Avnet Ultra96-V2
Revision 1 Errata
14 June 2019

Figure 3 – Ultra96-V2 Schematic Page for Pmic #2, 0x14

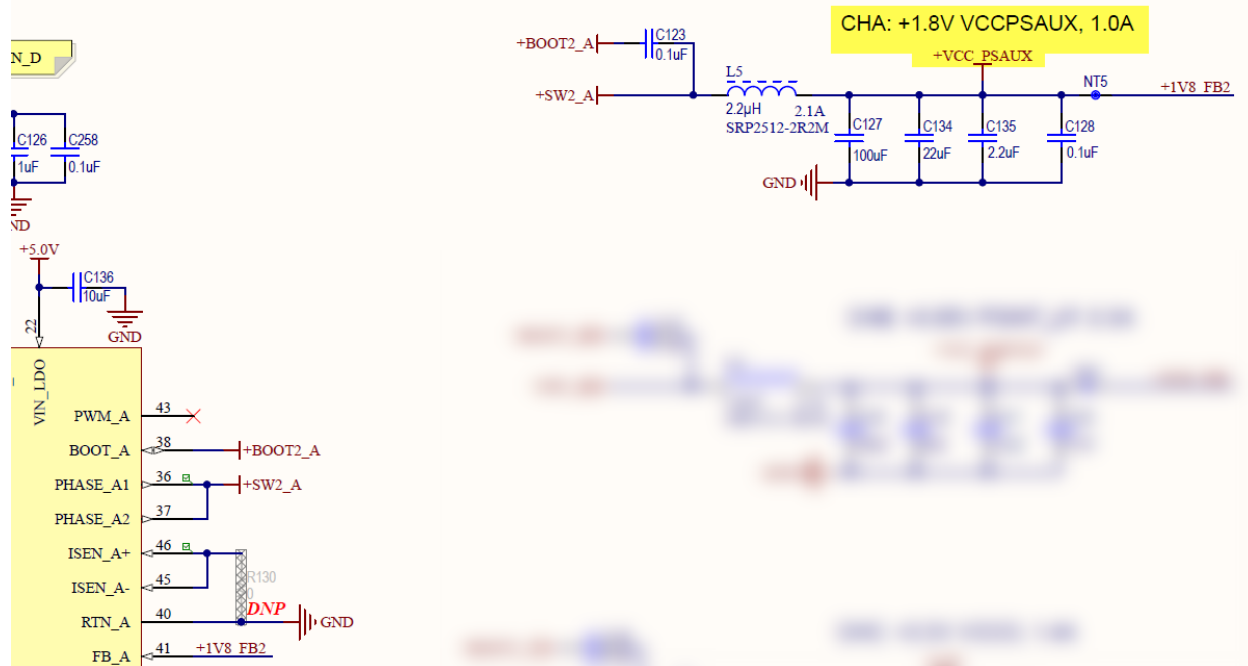
The Infineon Pmics used on Ultra96-V2 are programmable devices that include voltage value, warning, and fault settings. Reference Designator U12 is an Infineon IRPS5401 with an address setting of 0x14. Switcher A on this device delivers 1.8V to the Ultra96-V2 which is VCC_PSAUX. this can be seen on Sheet 16 of Ultra96-V2 Rev 1 schematics. This rail was designed to deliver a maximum steady-state current of 1.0A.

For the affected boards, the warning threshold was set too low, such that occasional current spikes will trigger an over-current warning. This is only seen if actively monitoring in the Infineon PowIRCenter software, as shown in the figures below. The warning does NOT affect the proper operation of the board.

It is not necessary to perform a work-around. This warning may be safely ignored. However, the Infineon Pmic warning thresholds may be adjusted to 1.5A to eliminate this warning.

The programming files will be adjusted to eliminate the warning on boards with datecode 1931 or later.
